Response to
Request for Additional Information No. 448(4898, 5084)
Supplement 9

U.S. EPR Standard Design Certification
AREVA NP Inc.
Docket No. 52-020
SRP Section: 03.08.01 - Concrete Containment
Application Section: 3.8.1

Question 03.08.01-51:**Follow-up to RAI 155, Question 3.8.1-22**

**Figure 03.08.01-51-1—Coarse Slice Model Mesh Density (a) Typical RCB
Section (b) Typical RCB Dome (c) Typical RCB Wall**

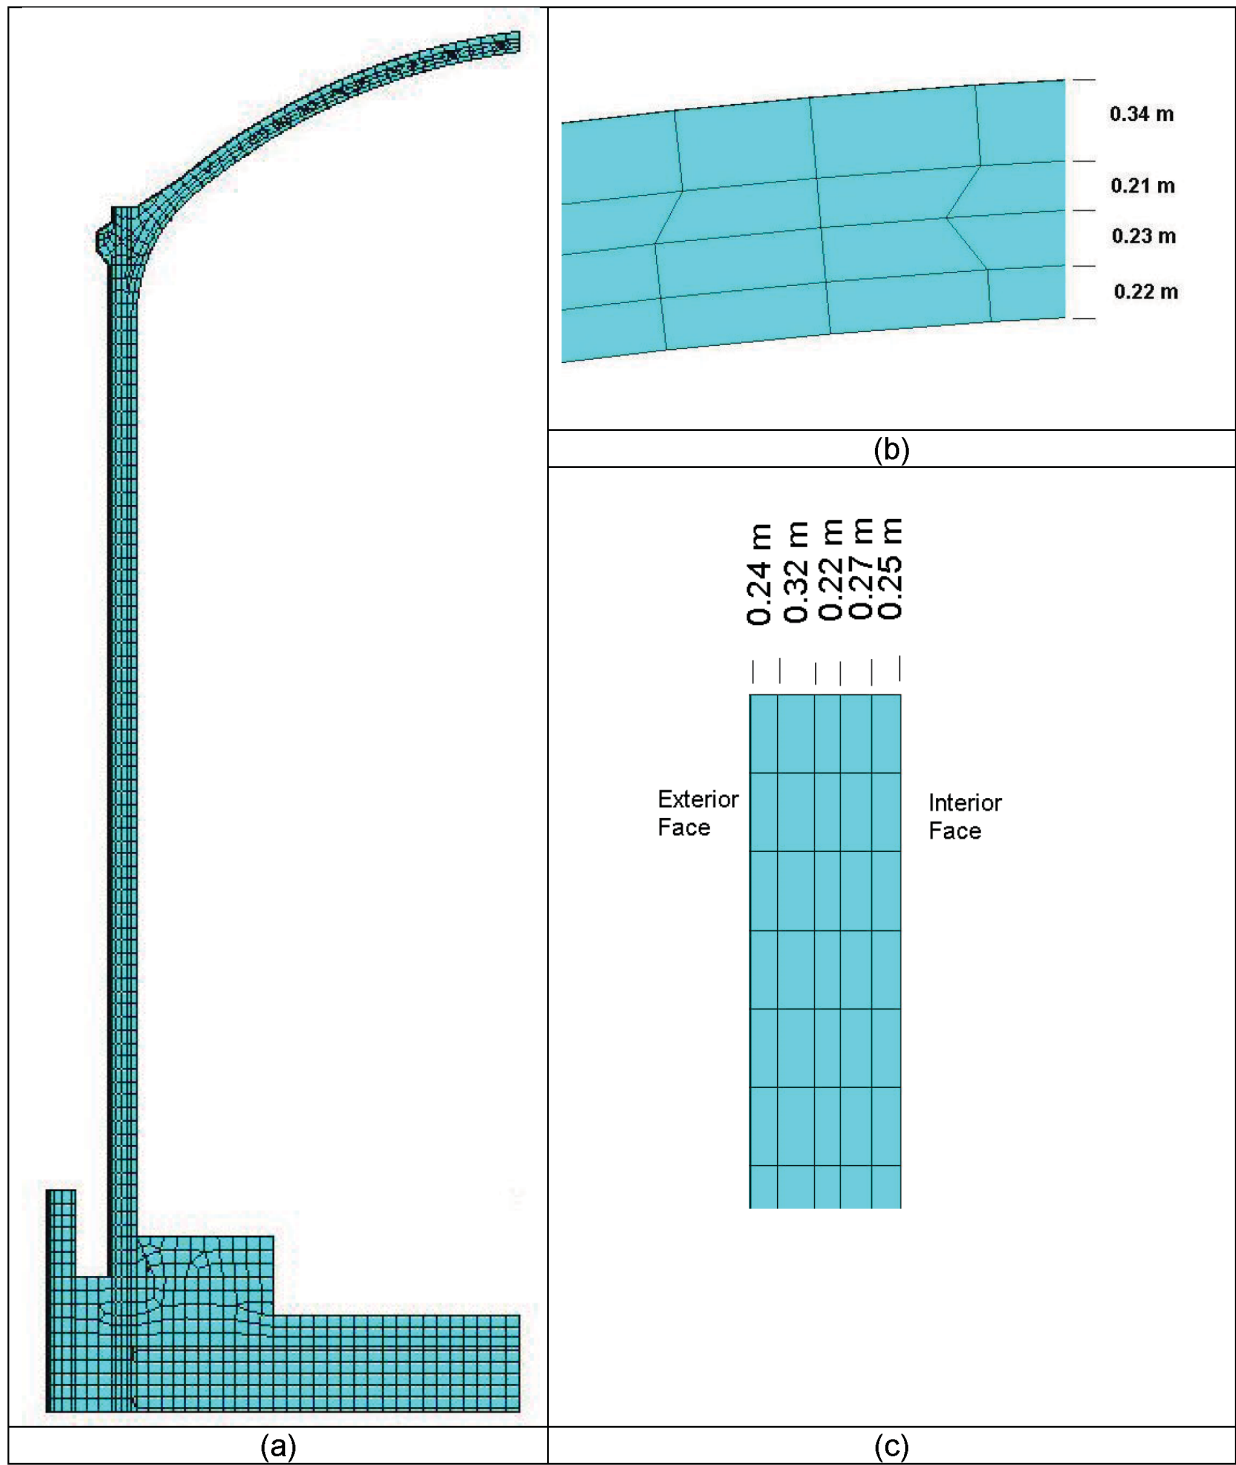
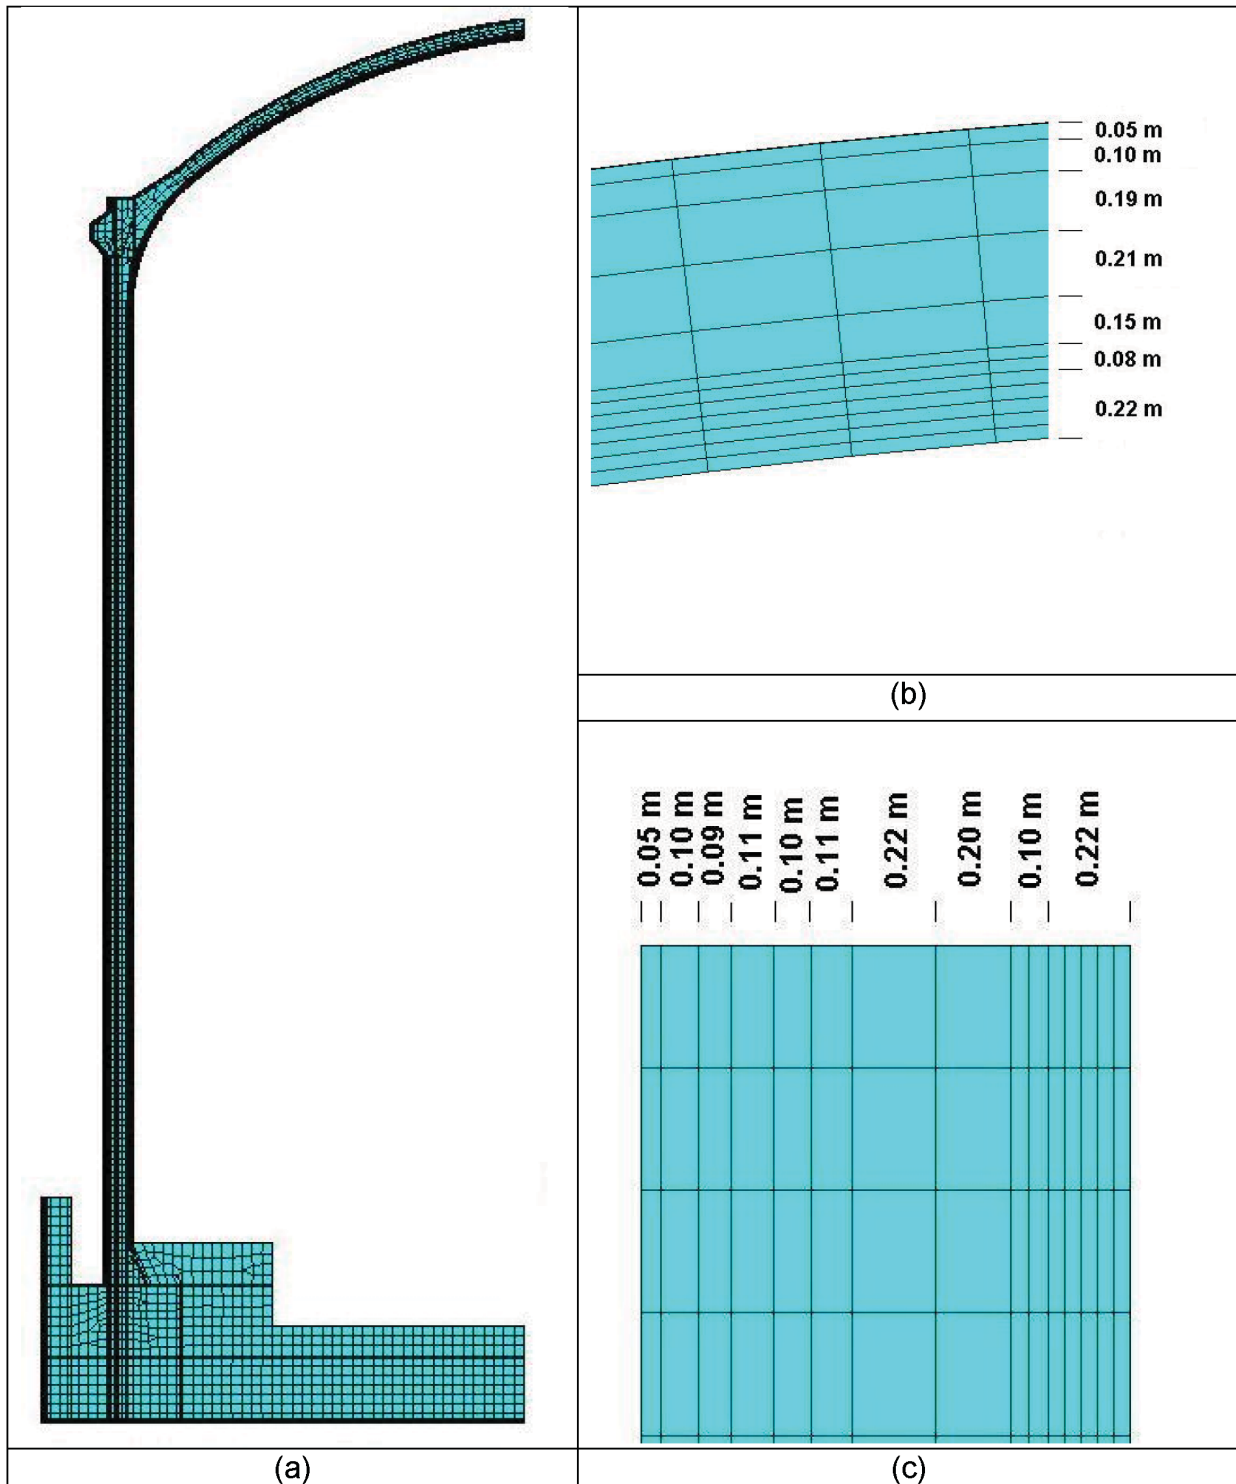
- a. The RAI response states that the mesh density in the 6-degree slice FEM model is increased to calculate the change in thermal moments due to mesh refinement. Provide a description of this mesh refinement, include a figure of each model, and identify the relative sizes of the original vs. the refined mesh.

In response to RAI 03.08.01-22, six-degree slice finite element model (FEM) models were considered with a coarse mesh density and refined mesh density. The slice model with coarse and refined mesh densities are referred to as “equivalent slice model” and “refined slice model,” respectively. The equivalent slice model has similar element thickness and mesh density as the Nuclear Island (NI) static model RCB, and contains five and four elements through thickness of the RCB wall and dome, respectively. The refined slice model has 15 and 12 elements through thickness of the RCB wall and dome, respectively. The equivalent and refined slice models are used for linear structural analysis of the model.

Figure 03.08.01-51-1 and Figure 03.08.01-51-2 show mesh densities of the RCB wall and dome for equivalent and refined slice models.

Figure 3.8-20—Accident Temperature versus Time (Reactor Containment Building)

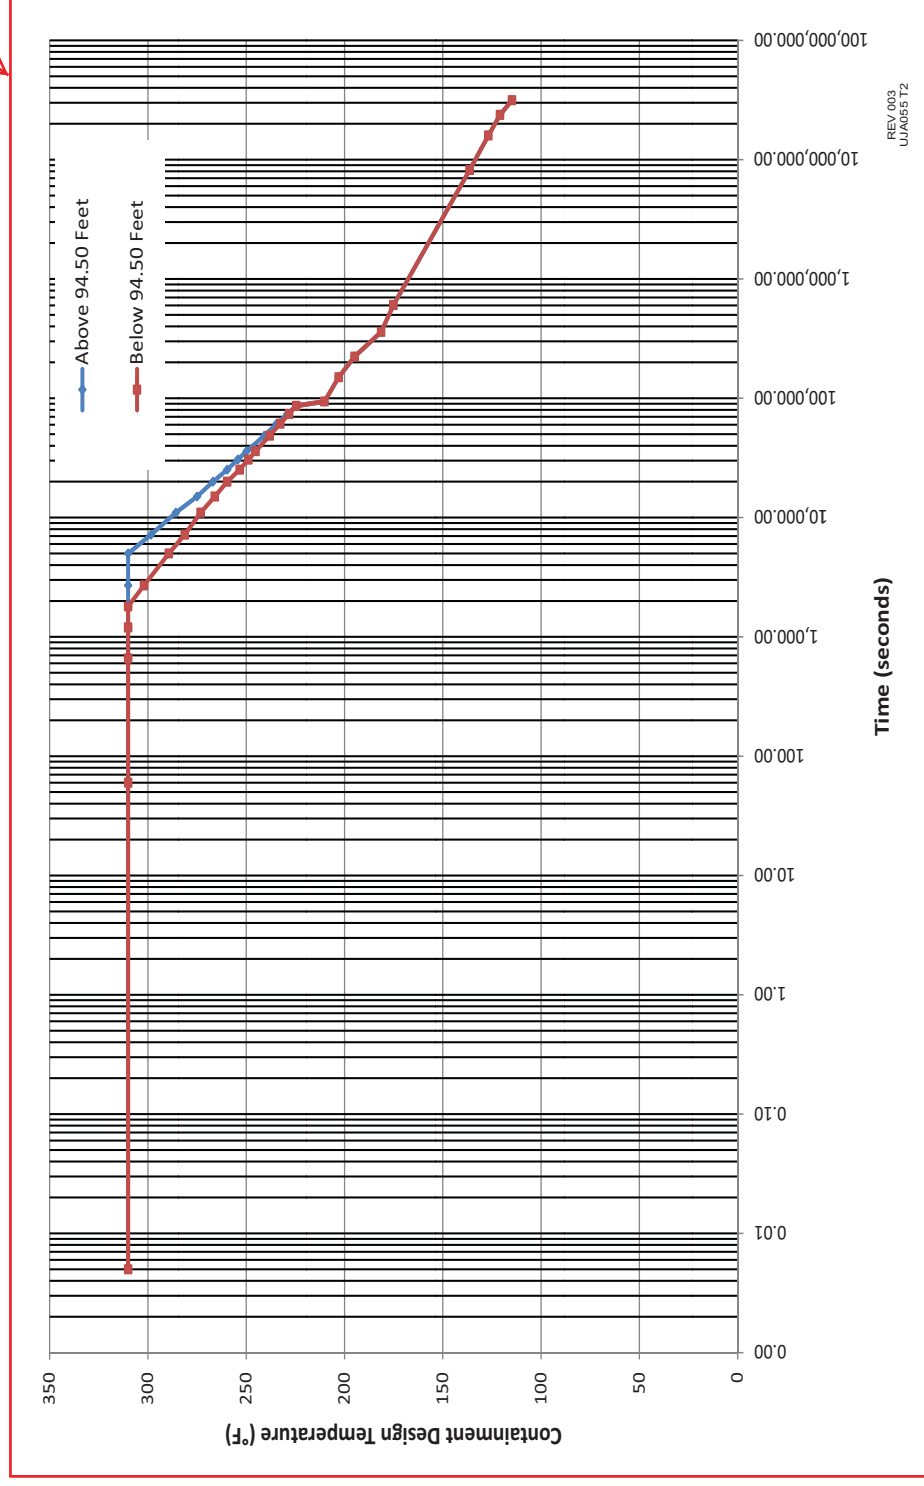
- f. Explain how the thermal loads are applied to the nonlinear FEM model. The RAI response simply states that “the model is subjected to accidental pressure loads,” or “the model is subjected to accidental temperature and pressure loads.” However, it is not clear whether the analysis considered the variation of the temperature gradient across the containment thickness at the four critical time points identified in the temperature and

U.S. EPR FSAR Tier 2, Section 3.8.1.4.5, Figure 3.8-20 through 3.8-24 will be revised as described in the response and indicated on the enclosed markup. A portion of the U.S. EPR FSAR changes associated with this response have already been included in Revision 3. Other portions of the FSAR changes will be incorporated into Interim Rev. 4 as identified in the FSAR markups.
